OHIO TURNPIKE AND
INFRASTRUCTURE COMMISSION

ADDENDUM NO. 2

PROJECT NO. 39-16-02 (PART A)
RIGHT TWO LANES AND SHOULDER RECONSTRUCTION
MILEPOST 186.35 TO MILEPOST 191.39
PORTAGE COUNTY, OHIO

PROJECT NO. 39-16-02 (PART B)
BRIDGE REPAIR & REHABILITATION
OHIO TURNPIKE OVER CUYAHOGA RIVER MILEPOST 191.40
PORTAGE COUNTY, OHIO

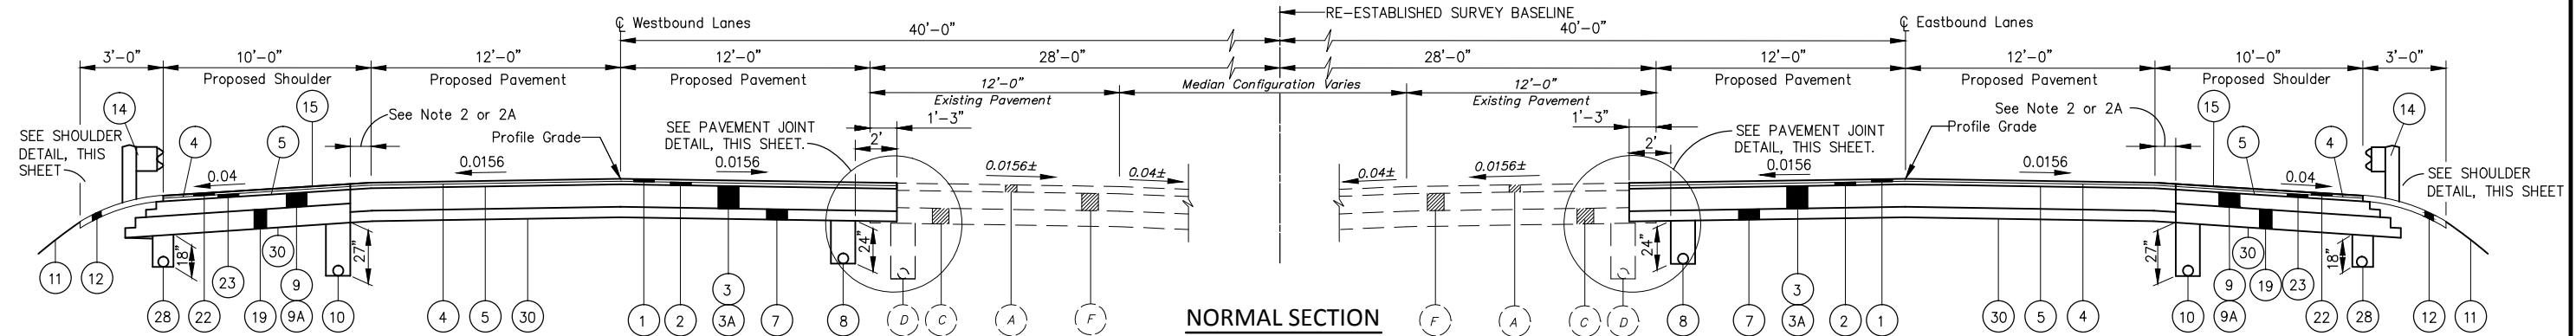
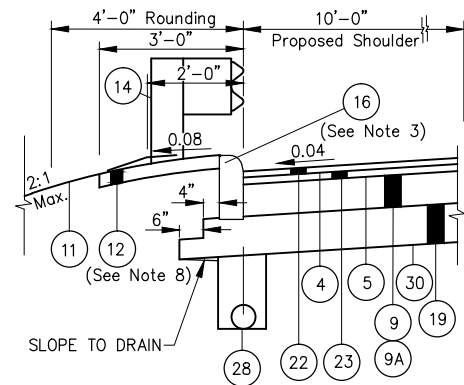
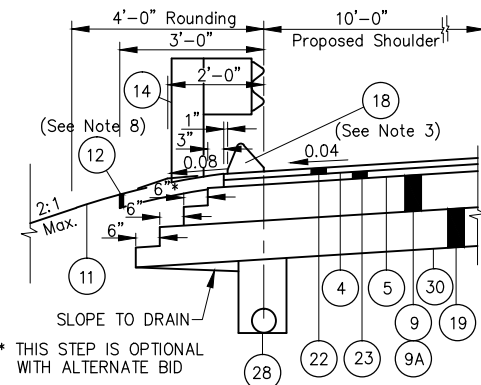
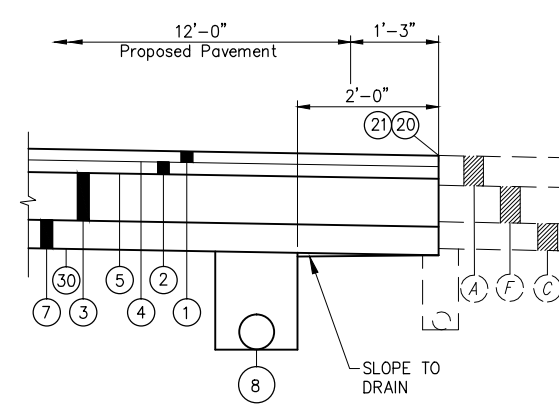
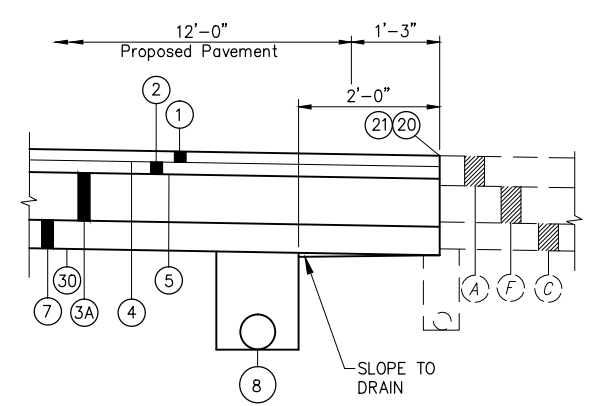
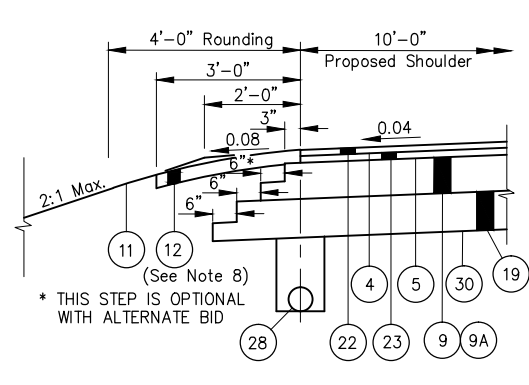
Plan Sheet No. 6 of 371 is modified to correct the Item Legend, Reference 12, Item SP 617 Compacted Aggregate, from "~~T=3~~" to "***T=6*** (without guardrail)"

| ⑫ ITEM SP 617 COMPACTED AGGREGATE, (T=6") (WITHOUT GUARDRAIL) | ③0 ITEM 206 CHEMICALLY STABILIZED SUBGRADE, AS PER PLAN, SEE SHEET 16. |
